**Re: Noon Day
2500 Second St NW
Request Permanent C.O. - Accepted
Engineer's Stamp dated: 12-5-13 (H14D067)
Certification dated: 11-26-14**

**RE: Noon Day, 2500 2nd St
Grading and Drainage Plan
Engineers Stamp Date 12/05/13 (H14-D067)
Engineer's Certification Date 11/4/2014**

**RE: Grading and Drainage Plan
Noon Day (H14-D067D)**

North Culvert
↓

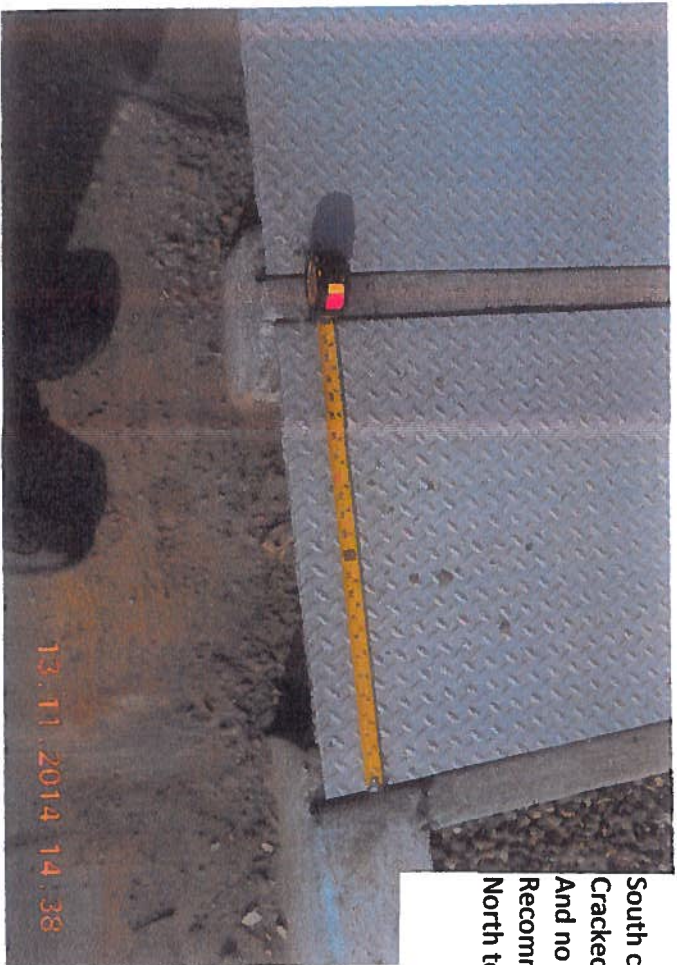
- provide calculations showing that the as-built width of the north sidewalk culverts is sufficient for drainage. It is built 17" wide but G&D calls for a 24" wide.
- On the north culvert, there is no expansion on both ends. Give room to have the 6" space for expansion on both ends. There is also no bar on street end of plate.
- The south culvert has a cracked center with missing concrete at face creating a tripping hazard. Recommendation is to remove south culvert, saw cut at cold joint ramp end.
- There is a cracked north side curb at cold joint through the back of curb, epoxy over bolts

North culvert plates 2 feet with 17 inch openings plan calls for two 24 inch. Plate is welded but there is no expansion on both ends the plate is painted no other deficiencies

Recommendation is to remove south culvert saw cut at cold joint ramp end. North to give room to have the 6 inch space to expansion at both ends

↖ South Culvert ↗

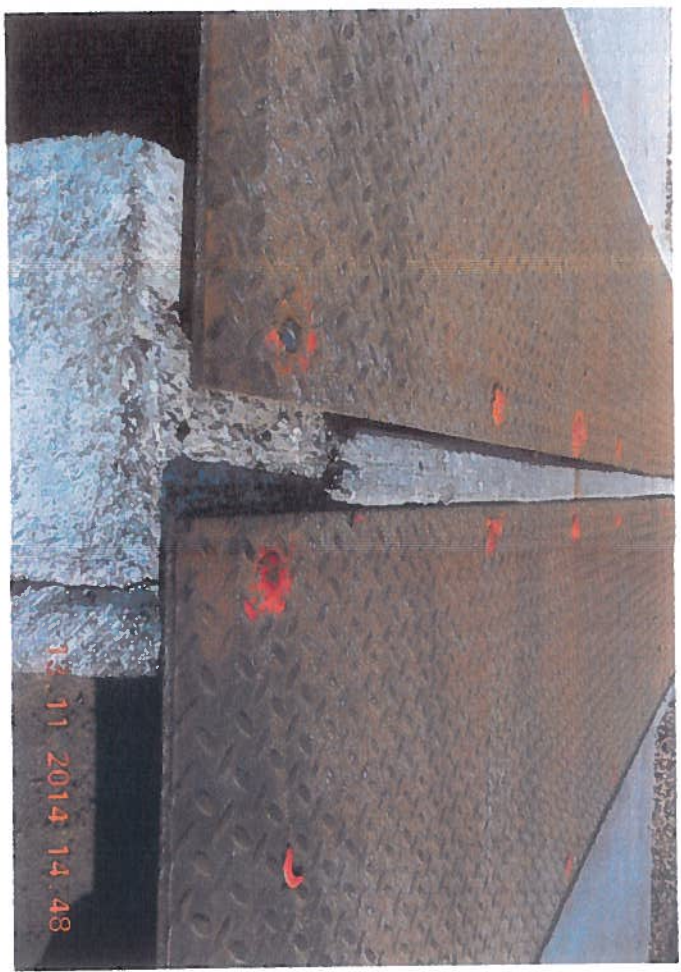
South culvert is a no pass cracked center with missing concrete at face tripping hazard. Cracked north side curb at cold joint through back of curb, epoxy over bolts. And no bar on street end of plate, openings are 17 inches.

Sidewalk culvert

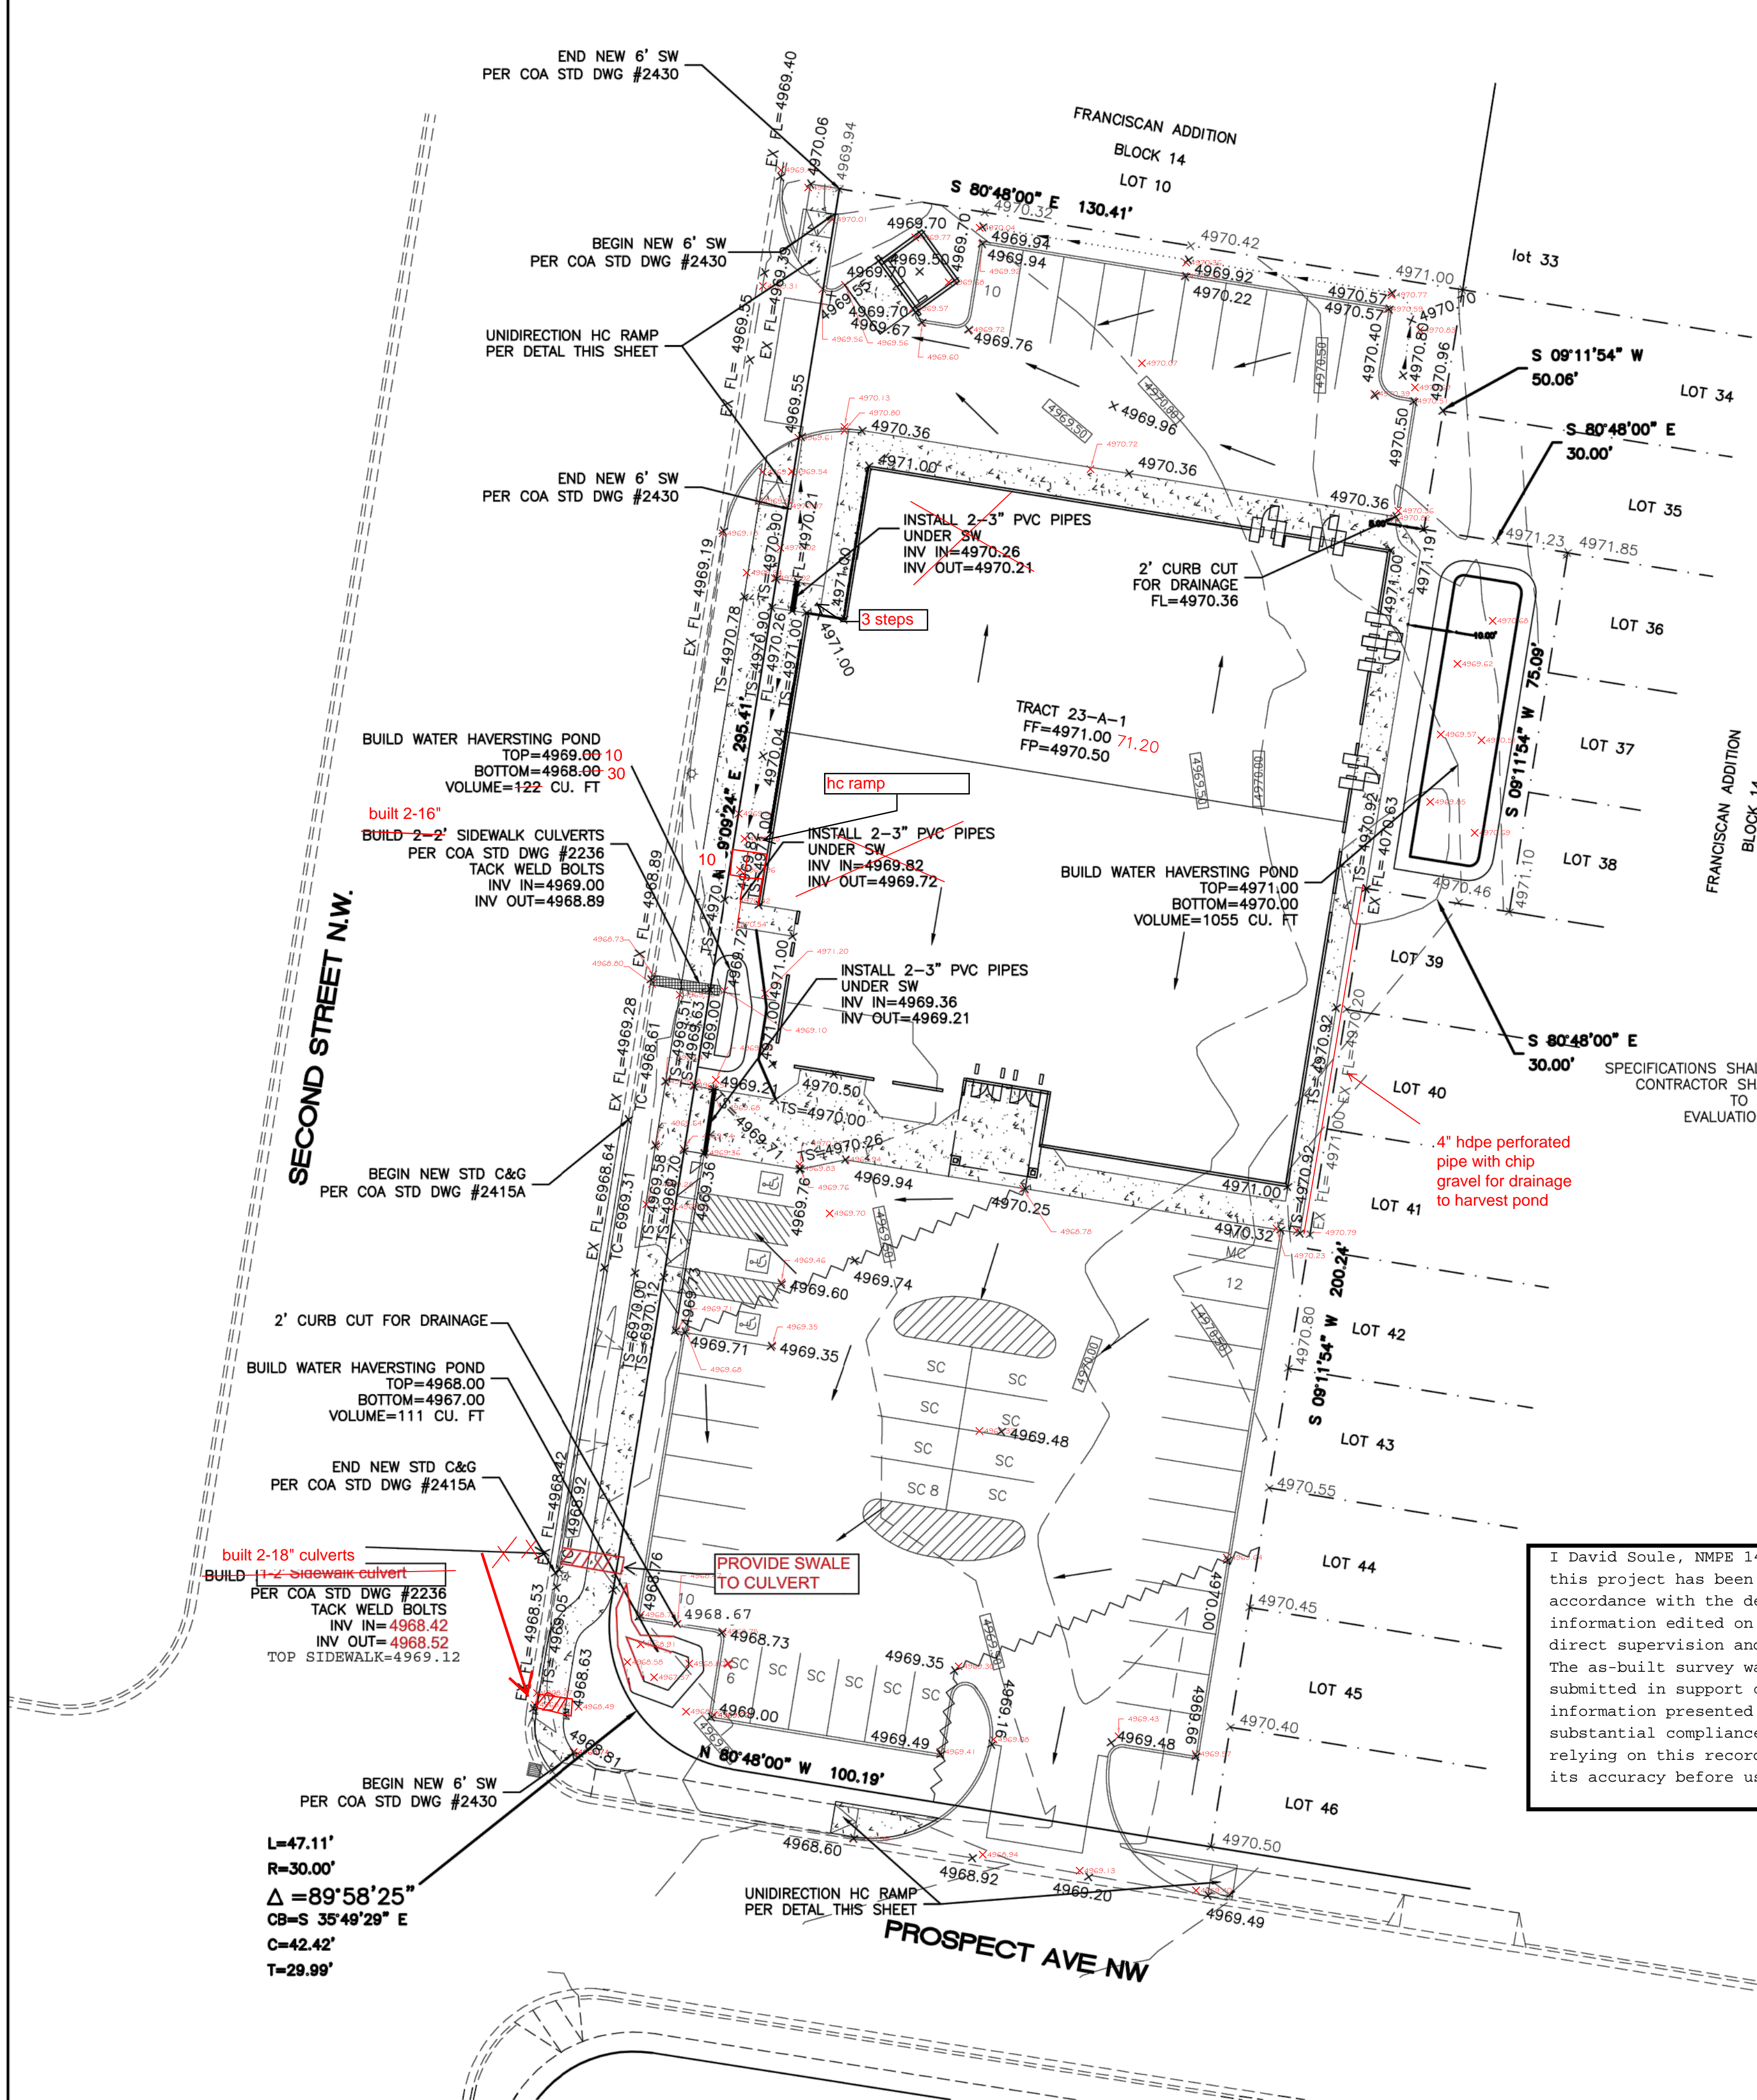
The purpose of this letter is to accompany the enclosed calculation to prove the proposed 2' sidewalk culvert that was constructed as a 16" culvert has the capacity to convey the contributing flow. Should you have any questions regarding this re-submittal, please do not hesitate to call me.

$$Q = 2.95 \times 1.5 \times 0.67^{1.5} = 2.42$$

there are two culverts so

$Q_{\text{allowable}} = 4.84 \text{ cfs} > Q_{\text{required}} = 1.85$
